Hunter Community Environment Centre

Submission to the Environmental Assessment

Port Waratah Coal Services Terminal 4, Project No. MP10_0215

Figure 11.24 from IEA World Energy Outlook 2011

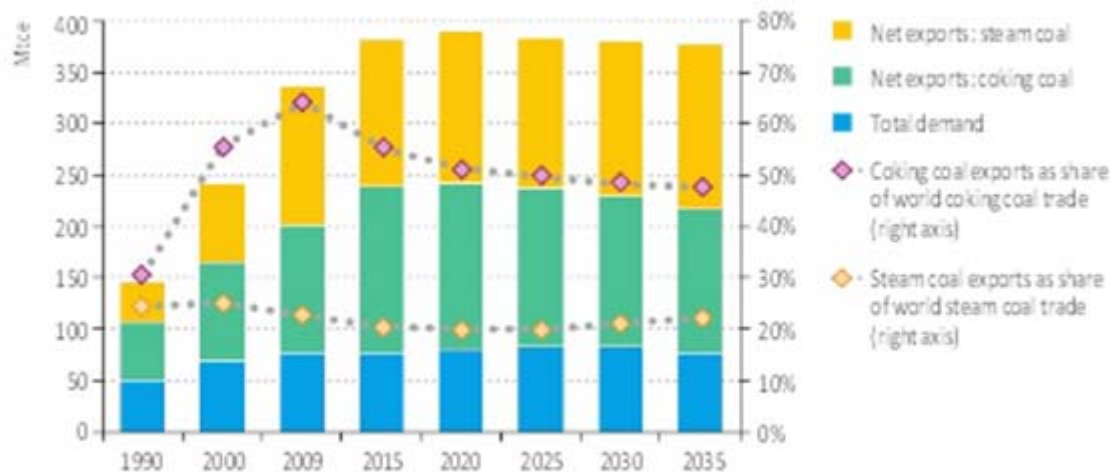
Under the IEA 'new policies' scenario total coal exports (coking and steaming) from Australia will peak at 310MT/yr around 2020 and then decline to 300 MT/yr by 2035 (see p438 World Energy Outlook 2011 and figure 11.24 reproduced below). As discussed above, by 2015 there will already be over 500 Mt/yr of coal port export capacity in Australia. The Terminal 4 proposal is therefore not needed and even if stage 1 of T4 is built, the capacity levels for stages 2 and 3 would not be triggered under any energy supply-demand path remotely similar to the one modelled for the IEA 'new policies' scenario. In such a case stage 1 of T4, if built, will be a high risk of becoming a stranded asset.

Critically the 'new policies' scenario is not a path that reduces CO₂ level sufficiently to avoid significant risks of dangerous climate change. Also in their World Energy Outlook 2011, the IEA modelled an energy scenario based on stabilising Greenhouse Gases at 450 parts per million by 2100. This '450 scenario' the IEA advises has a 50% chance of avoiding global warming of two degrees above pre-industrial temperatures. To meet this scenario the IEA states "*Global demand for both coal and oil [need to] peak before 2020, and then decline by 30% and 8% respectively by 2035, relative to their 2009 levels.*" (World Energy Outlook 2011).

If the world follows a similar path to the IEA 450 scenario (with actions based on the Durban platform) then it is likely that much of the existing coal port capacity in Australia will not be needed within a decade. New port capacity in the form of Terminal 4 would be unlikely to gain investment approval even if planning approval is granted. If T4 was built under this scenario it would quickly become a stranded asset.

Figure 36 from “The Critical Decade” by the Climate Commission

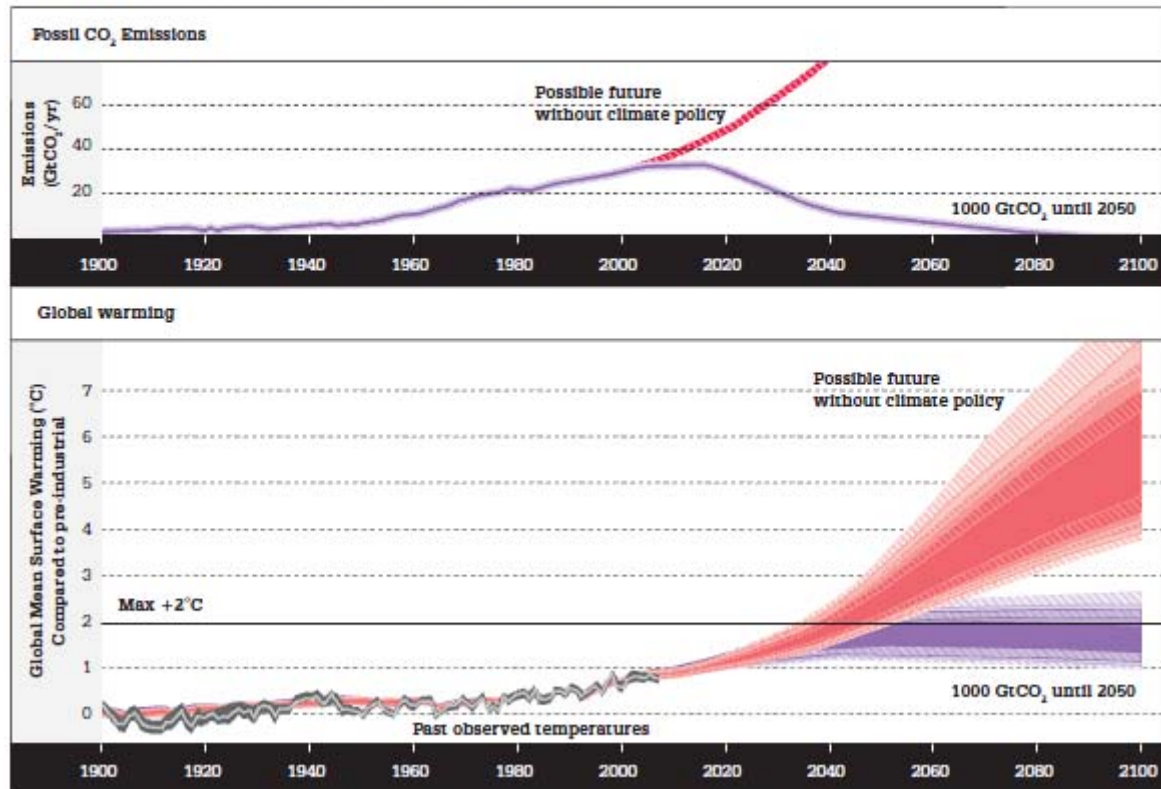
This proportion can be traced back to the Greenhouse Gas Assessment report (appendix N) where GHG emission related to the project are compared to both Australian and Global projected emissions. The figures used in the GHG report for comparisons are 2030 projections of 803 MTCO₂-e/yr for Australia and 70.4 GTCO₂-e/yr globally. These 2030 projections are high range and extreme. They are projects consistent with there being no action on climate change and increases in the concentrations of GHG in the atmosphere to over 1000ppm by 2050. Such an outcome is expected to lead to global warming in a range between 4 and 6 degree above pre-industrial temperatures and potentially higher by 2100 (Meinshausen et al 2009). Such temperature increases would have a significant risk of triggering runaway climate change.

The 803 MTCO₂-e/yr for Australia in 2030 used in the EA is a 'without action' scenario used by the Department of Climate Change (DCCEE, 2010) to contrast the impact of action that is occurring to meet the bipartisan 5% GHG reduction target from 2000 levels by 2020. This -5% target for Australia in 2020 is 530 MTCO₂-e/yr (DCCEE, 2010). Using high range projection for comparisons is misleading and the benchmarks for Australian emission used in the EA should be either current levels or legislated targets. Australia's 2011 total emissions were estimated at 547 MTCO₂-e/yr (DCCEE, 2012). Australia's only legislated by emissions target is for an 80% reduction by 2050 from 2000 levels or 110 MTCO₂-e/yr.

Globally a 70 GTCO₂-e/yr per year projection in 2030 is also a high end projection that is consistent with no global action on climate change. Using this as a benchmark for the projects scope 3 emission gives a misleading picture of the T4 projects global significance. The IEA estimate of global GHG emissions in 2010 of 30.6 GT CO₂-e (IEA, 2011) would provide a more balanced benchmark.

If the EA does seek to include comparisons to projected 2030 emission then these should be consistent with global action on climate change that is in line with Australian Government policy and global agreements. One projection that could be utilised in the EA is from the Australian Government's Climate Commission. In its "The Critical Decade" report (2011) the Climate Commission has global emissions reducing to about 20 GTCO₂-e/yr per year based on what is needed to meet a goal of keeping average temperature increases below 2.0°C (see figure 36 from that report reproduced below). The 299MT CO₂-e/yr per year attributed to T4 in the EA would be 1.5% of this 20 GTCO₂-e/yr global emission figure.
